Access Compliance Report

Public Rights-of-Way

(Curb Ramps)

Intersection ID: 47661	Main Street: CANDLESTICK_CT	Cross Street: FENWAY_DR	Location: SW
ADA ID: 2A20DD578030	Ramp Type: PerpDiag	Initial Pass/Fail: Fail	Overall Compliance: No
		Severity Score: 12.5

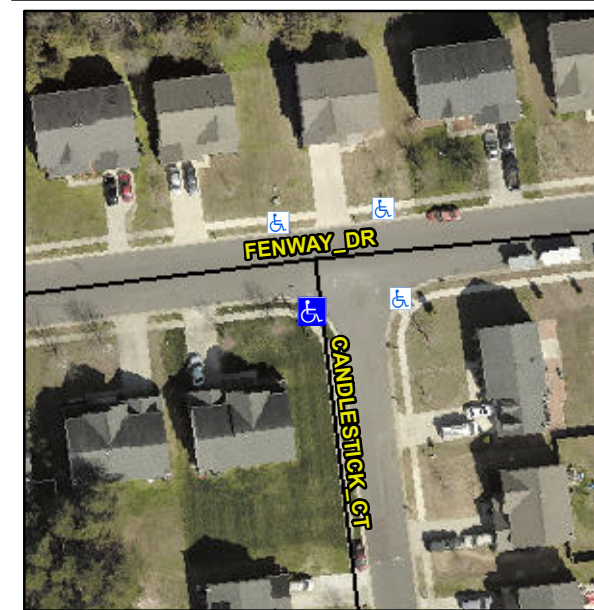
R304.2.2

Compliance	Description	Data	Compliance	Description	Data
N/A	Ramp Length (in)	53.0	No	Ramp Slope (%)	9.1
Yes	Ramp Width (in)	48.0	Yes	Ramp XSlope (%)	0.1
N/A	Flare Type LT	N/A	N/A	Flare Type RT	N/A
N/A	Flare Slope LT (%)	N/A	N/A	Flare Slope RT (%)	N/A
N/A	Flare Traversable LT?	N/A	N/A	Flare Traversable RT?	N/A
N/A	Landing Length (in)	N/A	N/A	DWS Provided?	N/A
N/A	Landing Width (in)	N/A	N/A	DWS Contrast?	N/A
N/A	Landing Slope (%)	N/A	N/A	DWS Length (in)	N/A
N/A	Landing X Slope (%)	N/A	N/A	DWS Full Width?	N/A
N/A	Landing Curb? (Y/N)	N/A	N/A	DWS Offset (in)	N/A
N/A	Shared Landing?	N/A			
N/A	Gutter Ponding?	N/A	N/A	Gutter Slope (%)	N/A
N/A	Gutter Lip Ht (in)	N/A	N/A	Gutter X Slope (%)	N/A
N/A	Painted X Walk1?	No	N/A	Painted X Walk2?	No
	X Walk 1 Direction	To E		X Walk 2 Direction	To N
N/A	X Walk 1 Width (in)	N/A	N/A	X Walk 2 Width (in)	N/A
	X Walk 1 Slope (%)	0.8		X Walk 2 Slope (%)	1.4
	X Walk 1 X Slope (%)	0.7		X Walk 2 X Slope (%)	3.3

Remove & Replace Curb Ramp With Two New Directional Ramps or Equivalent.
